UNITED STATES PATENT AND TRADEMARK OFFICE

APPLICATION NO.	FILING DATE	FIRST NAMED INVENTOR	ATTORNEY DOCKET NO.	CONFIRMATION NO.
09/760,384	01/11/2001	Hau H. Duong	A-68718-2/RFT/RMS/RMK	2482

Office Action Summary	Application No.		Applicant(s)	
	09/760,384		DUONG ET AL.	
	Examiner		Art Unit	
	Brian J. Sines		1743

DETAILED ACTION

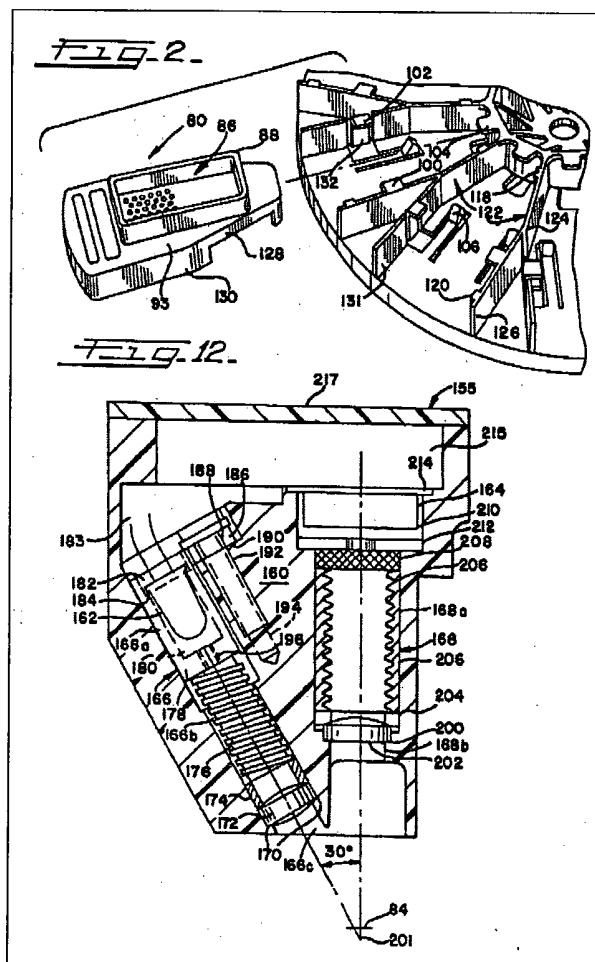
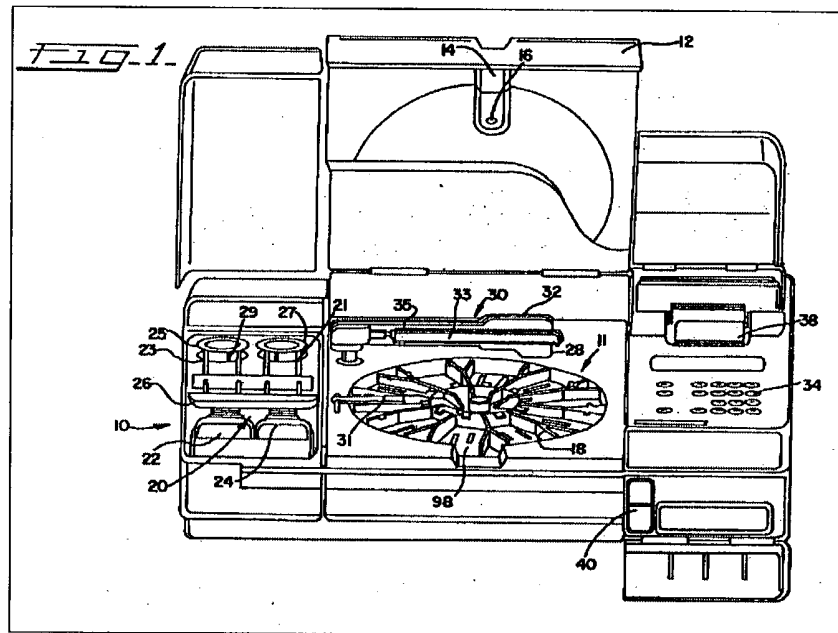
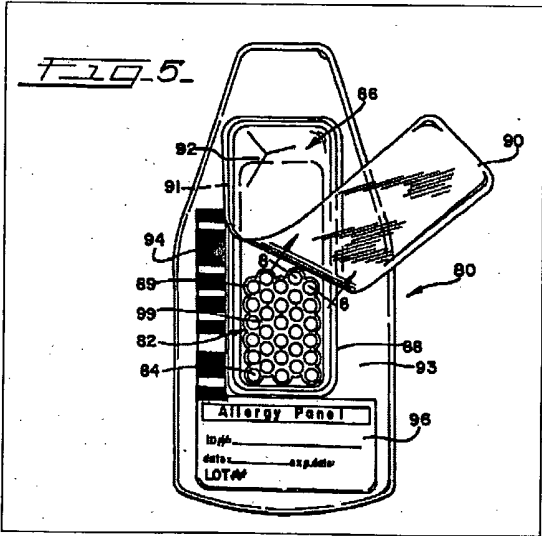
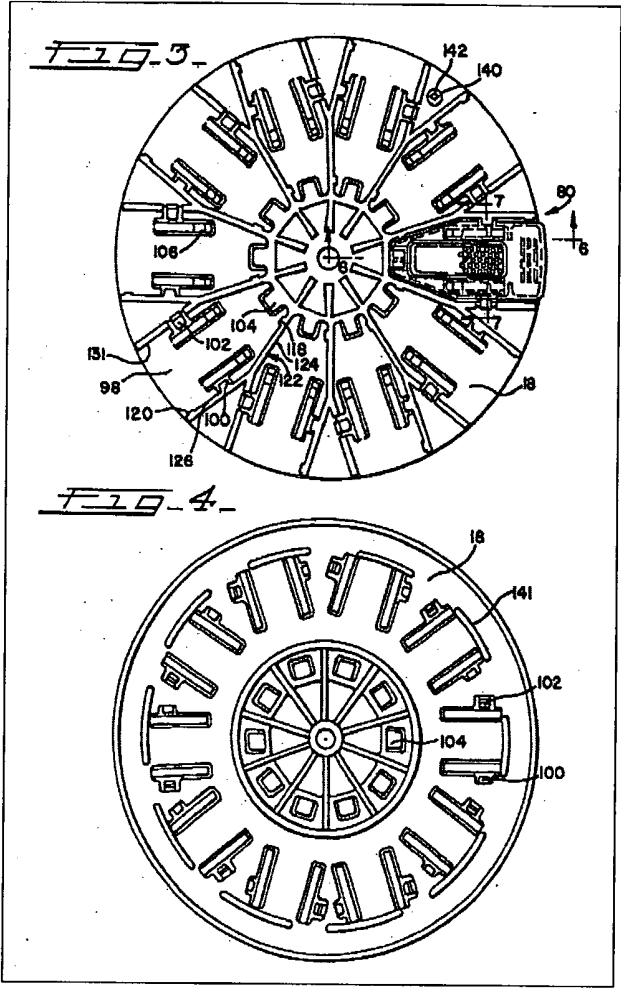
(a) inserting a first biochip (reaction cartridge 80) into a first station (opening 98 on carousel 18) of an analysis device (10);

(b) inserting a second biochip into a second station of the analysis device, wherein each of the first and second biochips comprise a substrate (test card 82) comprising an array comprising a plurality of test sites (84), wherein each test site (84) is comprising:

i) a different capture binding ligand (e.g., a capture reagent, such as antibodies, antigens, anti-biotin, avidin, lectins, peptide sequence probes or specific allergen which binds human IgE class antibodies from a patient serum sample);

ii) a different target analyte (e.g., a specific binding component, such as antigens from a patients sample, such as from serum, blood, urine, cerebrospinal fluid (CSF) or saliva);
and

iii) a label (e.g., a human IgE class antibody conjugated to an enzyme, such as alkaline phosphatase or horse radish peroxide (HRPO) conjugate, or any other detectable enzymatic or fluorogenic conjugate);

(c) detecting the presence of the label on the first biochip utilizing optical reader (32) from the test sites (84) from the reaction cartridge (80); and

(d) detecting the presence of the label on the second biochip (see col. 6, line 10 – col. col. 20, line 38; figures 2, 3 & 5).
